BLUE BIRD

S19AC

Subject: S19AC, Rear Engine Exhaust Hanger Rod Fastener Torque

Models Affected: Model Year: Certain 2018 to 2020 (School Bus and Non-school Bus)
Model: All American

Figure 1

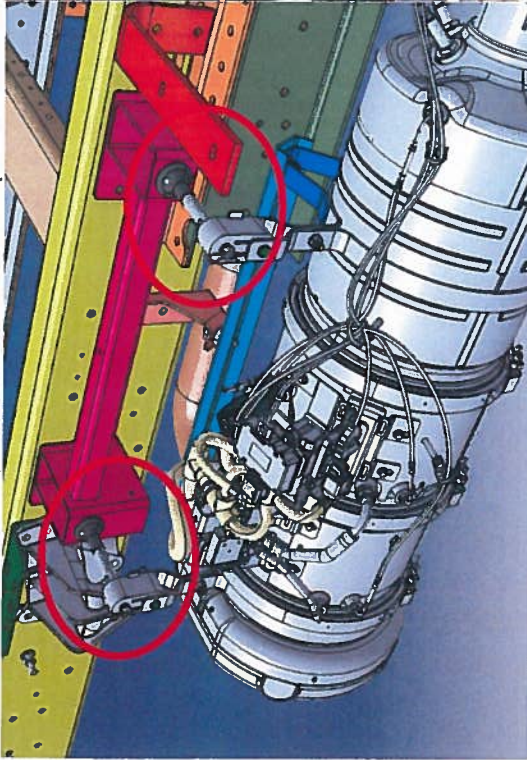
1. Locate the exhaust hanger rods that supports the muffler. (See figure 1)
2. Using a torque wrench with a 17mm crow's foot on the flat portion of the hanger rod, check torque on rods to ensure they are torqued to 60-64 FT-LBS. (See Figure 2)
3. If both exhaust hanger rods torque is correct, no further action is required.

Muffler hanger rod fastener.
Torque 60-64 FT-LBS

1. Use a floor jack and a block of wood to hold the weight of the exhaust canister.
2. Remove one exhaust hanger bolt at a time.
3. Using a pneumatic 90 degree impact with a 3" extension and 5/8" socket, remove the exhaust hanger bolt. Use a 17mm wrench to hold the exhaust hanger rod to keep it from spinning.
4. Once bolt is removed, apply Loctite to bolt threads.
5. Reinstall the exhaust hanger bolt into the exhaust hanger rod starting the threads by hand to ensure the bolt does not cross thread.
6. Using the pneumatic 90 degree impact, turn the bolt into the exhaust hanger rod until it is tight.
7. Using a torque wrench with a 17mm crow's foot, check torque on exhaust hanger rod and ensure it is torqued to 60-64 FT.-LBS.
8. Repeat for the second exhaust hanger bolt.
